ADVANCED RELEASE

TO: Holders of RR300 Series Operations and Maintenance Manual, Publication CSP 21009.

Reason: Revised inspection procedure.

COMPRESSOR FRONT SUPPORT ASSEMBLY INSPECTION/CHECK

Compressor Front Support - Inspection/Check
FIG. 801/TASK 72-30-10-990-801

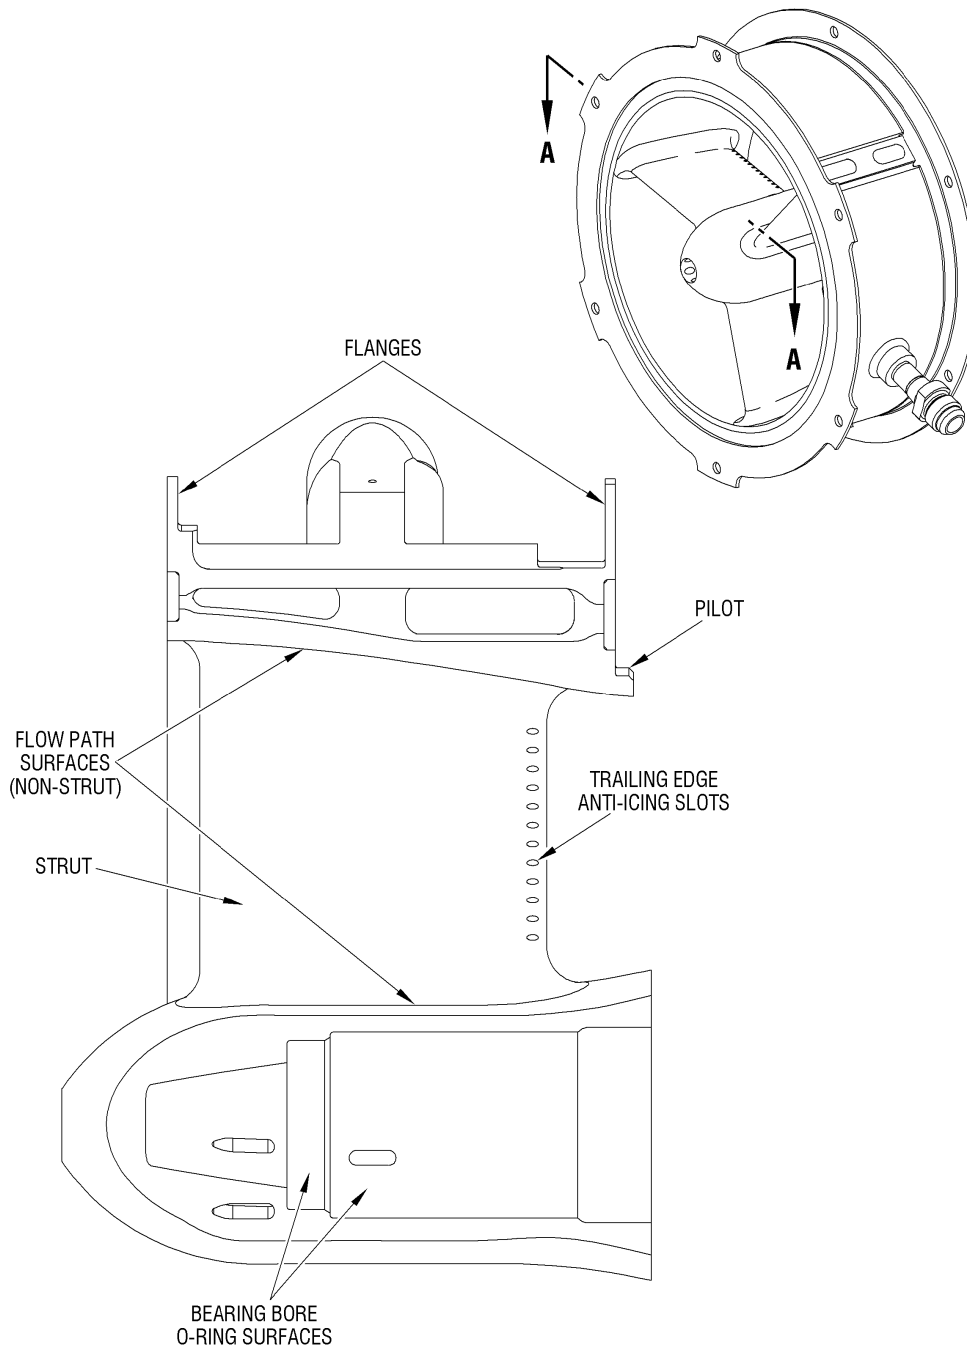
(1) Do the visual inspection of the compressor front support assembly (support).

(a) Do the visual inspection of the support when it is removed to the limits that follow:

ITEM	SERVICEABLE LIMITS	REPAIR LIMITS	ACTION NECESSARY
Cracks or linear indications	None permitted.	There is no limit to the quantity.	Replace the support.
Flow path area (non-strut)			
- Nicks or dents	Maximum diameter of 0.040 in. (1.02 mm) with a maximum depth of 0.020 in. (0.51 mm).	There is no limit to the quantity.	Replace the support.
- Scratches	Maximum length of 0.100 in. (2.54 mm) with a maximum depth of 0.020 in. (0.51 mm).	There is no limit to the quantity.	Replace the support.
- High metal	None permitted.	There is no limit to the quantity.	Remove the high metal by blending (Ref. TASK 70-33-03-300-801).

ITEM	SERVICEABLE LIMITS	REPAIR LIMITS	ACTION NECESSARY
- Nicks or dents	Maximum diameter of 0.040 in. (1.02 mm) with a maximum depth of 0.010 in. (0.25 mm).	There is no limit to the quantity.	Replace the support.

- Scratches	Maximum length of 0.100 in. (2.54 mm) with a maximum depth of 0.010 in. (0.25 mm).	There is no limit to the quantity.	Replace the support.
- High metal	None permitted.	There is no limit to the quantity.	Remove the high metal by blending (Ref. TASK 70-33-03-300-801).
Bearing bore (non-O-ring surfaces)

- Nicks or dents	Maximum diameter of 0.025 in. (0.64 mm) with a maximum depth of 0.010 in. (0.25 mm).	There is no limit to the quantity.	Replace the support.

- Scratches	Maximum length of 0.200 in. (5.08 mm) with a maximum depth of 0.010 in. (0.25 mm).	There is no limit to the quantity.	Replace the support.
- High metal	None permitted.	There is no limit to the quantity.	Remove the high metal by blending (Ref. TASK 70-33-03-300-801).

- Wear from No. 1 bearing pin	Maximum axial (fore and aft) width of 0.100 in. (2.54 mm).	There is no limit to the quantity.	Replace the support.
Bearing bore (O-ring surfaces)

- Nicks or dents	None permitted.	There is no limit to the quantity.	Replace the support.
- Scratches	None permitted.	There is no limit to the quantity.	Replace the support.

- High metal	None permitted.	There is no limit to the quantity.	Remove the high metal by blending. Keep the circumferential sequence of the surface texture. Do not make axial scratches (Ref. TASK 70-33-03-300-801).
Fore and aft flanges

- Nicks or dents	Maximum diameter of 0.040 in. (1.02 mm) with a maximum depth of 0.010 in. (0.25 mm).	There is no limit to the quantity.	Replace the support.

ITEM	SERVICEABLE LIMITS	REPAIR LIMITS	ACTION NECESSARY
- Scratches	Maximum length of 0.200 in. (5.08 mm) with a maximum depth of 0.010 in. (0.25 mm).	There is no limit to the quantity.	Replace the support.
- High metal	None permitted.	There is no limit to the quantity.	Remove the high metal by blending (Ref. TASK 70-33-03-300-801).
Pilot			
- High metal	None permitted.	There is no limit to the quantity.	Remove the high metal by blending (Ref. TASK 70-33-03-300-801).
Threaded fittings			
- Damaged threads	None permitted.	There is no limit to the quantity.	Replace the support.
- Axial scratches on seal surface	None permitted.	There is no limit to the quantity.	Replace the support.
Strut trailing edge anti-icing slot			
- Blockage	None permitted.	There is no limit to the quantity.	Replace the support.
